# Technical Service Information

## THM 4L60 (700-R4) HARSH DOWNSHIFT CLUNK IN D3 ONLY

Figure 1

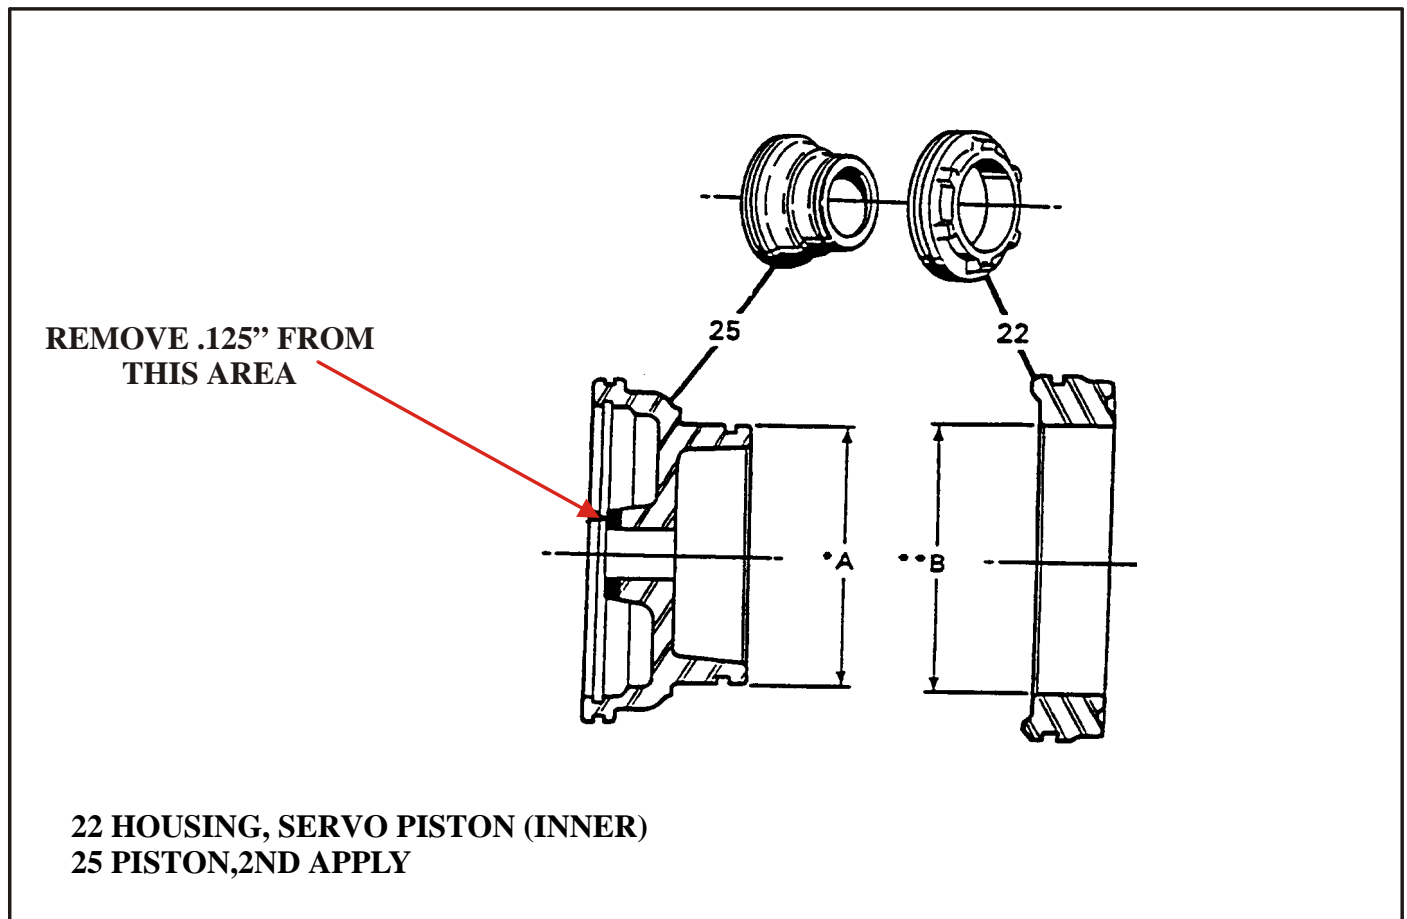
**COMPLAINT:** Harsh downshift clunk with selector in D3 only.

**CAUSE:** The cause could be the 2nd apply piston.

**CORRECTION:** Modify the 2nd apply piston by machining the inner hub and remove .125" (See Figure 1).
